Re: EB-2024-0111 Enbridge Gas Inc. (EGI)
2024 Cost of Service Phase 2
Interrogatories of the Vulnerable Energy Consumers Coalition (VECC)

REQUESTOR NAME	VECC
TO:	Enbridge Gas Inc. (EGI)
DATE:	June 19, 2024
CASE NO:	EB-2022-0200
APPLICATION NAME	2024 Cost of Service Phase 2

Figure 1: Residential Annual Heating Bill (Rate 1) – January 2024

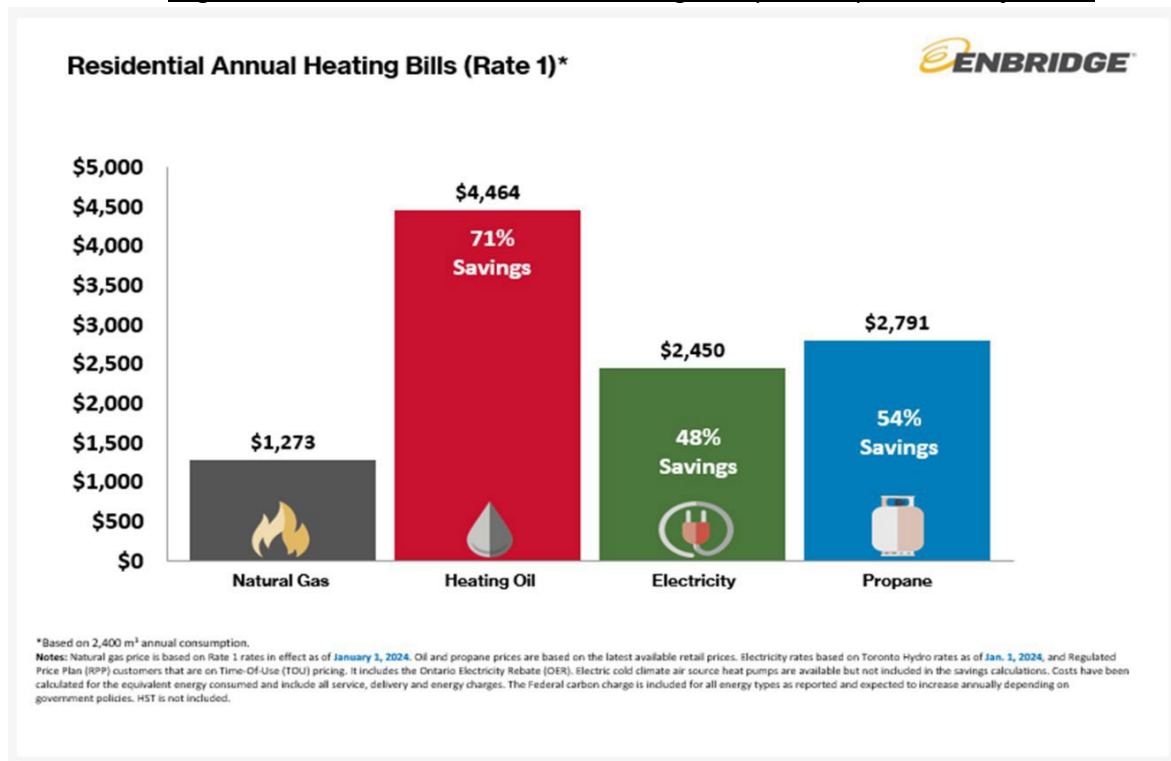
- Are the dollar amounts in Figure 1 calculated only based on space heating requirements?
- Does the fact that natural gas consumers typically use natural gas for water heating and (less often) for other appliances mean that the above chart likely underestimate the savings for a typical natural gas residential consumer?
- How many complaints per year does EGL receive from customers believing they were misled by the Utility as to the potential for costs savings by switching to natural gas?

**Estimated annual heating bills for typical residential customer
(Rate 1)**

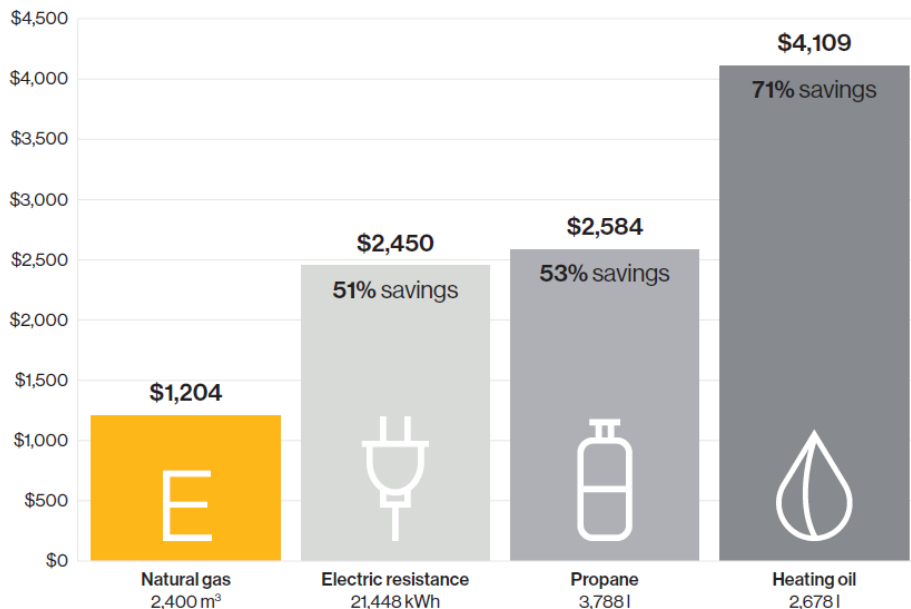
- a) Why does EGI not include heat pump sourced space heating in its comparisons?
